CONDITIONS OF APPROVAL:

Engineering - Final Plat Checklist

FAMILY LEGACY PUD SUBDIVISION (LIFE CELEBRATION CENTER OF FRANKLIN) - submittal 001.pdf

19. Ingress/Egress Easement

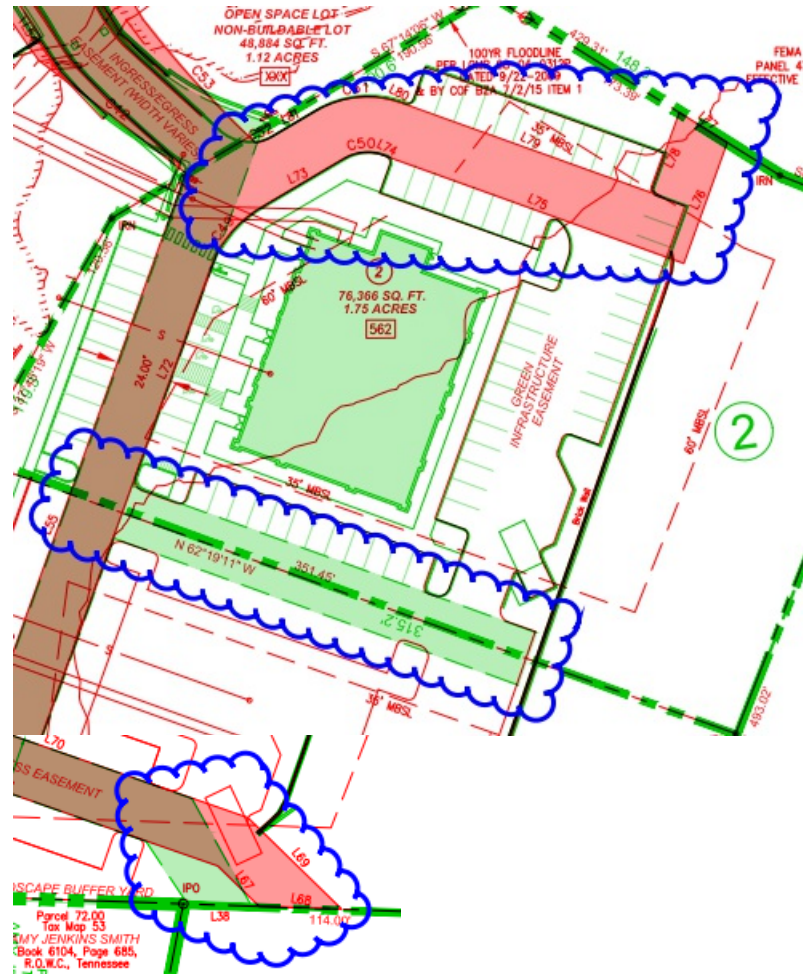
joe.marlo@franklin.tn.gov Comment not adequately addressed. There remain several locations where the access easement shown on the Final Plat does not match the associated Site Plan. See overlay below (Site Plan - Green, Final Plat - Red, Areas of Overlay - Brown).

Applicant to revise the Ingress/Egress Easement on the Final Plat to match the associated Site Plan. Hatch the access easement on the Final Plat to clarify its location.

20. Green Infrastructure Easement

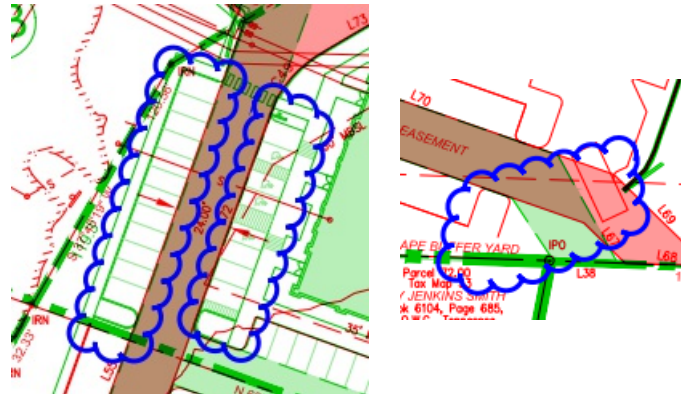
joe.marlo@franklin.tn.gov Comment partially addressed, however extents of GIEs remain unclear in some locations on the final plat. See overlay below (Site Plan - Green, Final Plat - Red, Areas of Overlay - Brown).

Applicant to clarify the extents of the Green Infrastructure Easements (GIE) on the Final Plat, particularly at the locations clouded below. Applicant to hatch the extents of the GIEs on the final plat for clarity.

30. Final Plat Text

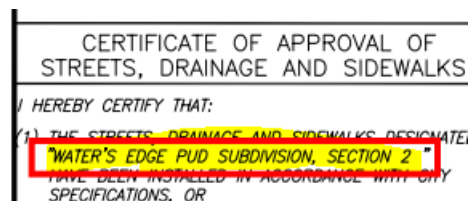
1. Sheet 1 should be labeled "Sheet 1 of 3".

2. Remove all references to Water's Edge PUD, including those in the Certificate blocks, as highlighted below.

31. FFO

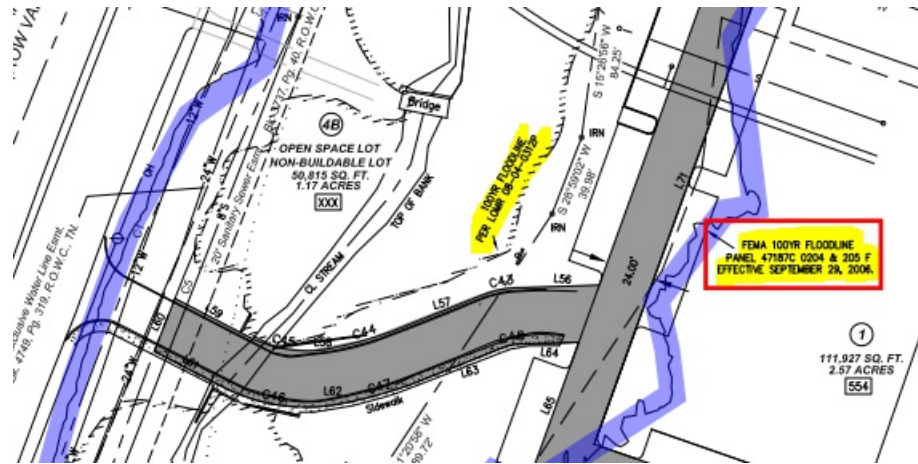
Per comments made by the COF Floodplain Administrator to the associated PUD (COF 6612), Applicant to remove the flood line from the FEMA FIRM panel dated September 29, 2006 that runs through the buildable lots. As noted on the plat, this went through BZA and the boundary has been relocated outside the buildable lots.
